# KENWOOD

ASB-1003

## Service Bulletin

**Subject:** TS-950SDX w/K1EA Ver.8 Program  
1992

## TS-950SDX Side view

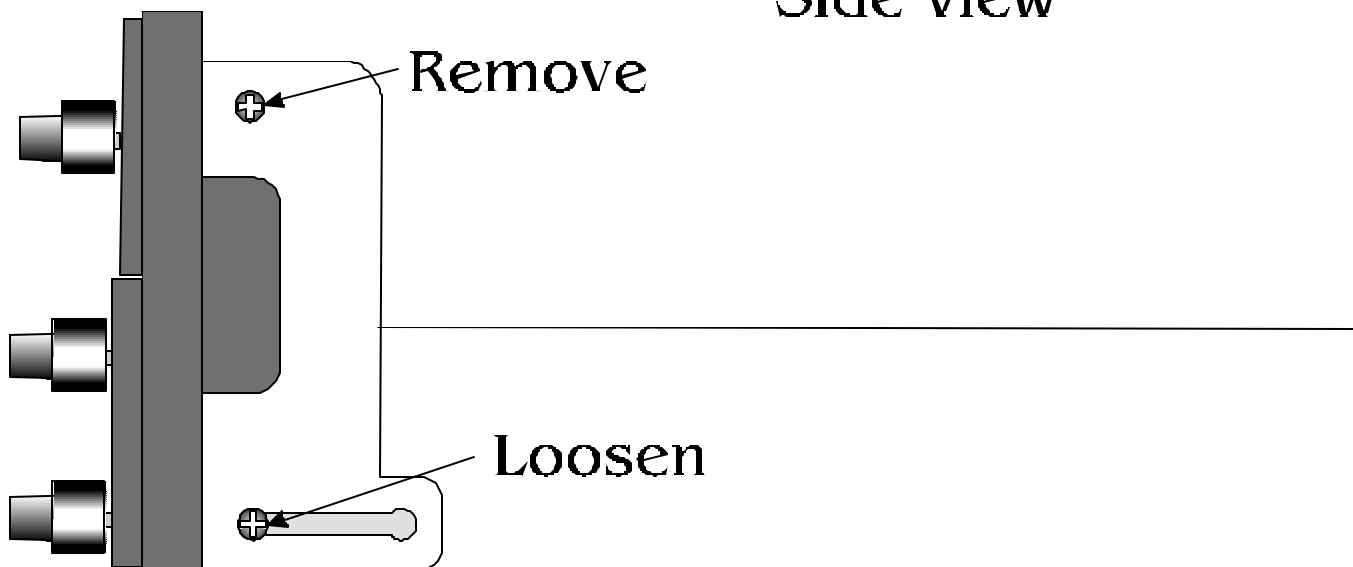
1. Remove the top and bottom covers of the TS-950SDX.
2. Carefully unplug the two DSP unit cables from the rear of the transceiver.
3. The front panel of the radio is designed to allow it to be tilted forward for ease of service. To tilt the front panel forward remove the screw at the top of the brackets that secure the front panel to the chassis. (Please refer to the accompanying diagram.) There is one screw on each side of the front panel.

4. Next loosen the remaining screw at the bottom of each bracket.
5. Gently pull the bottom of the front panel forward until it reaches the end of the slot in the bracket and gently pull the top of the front panel down.
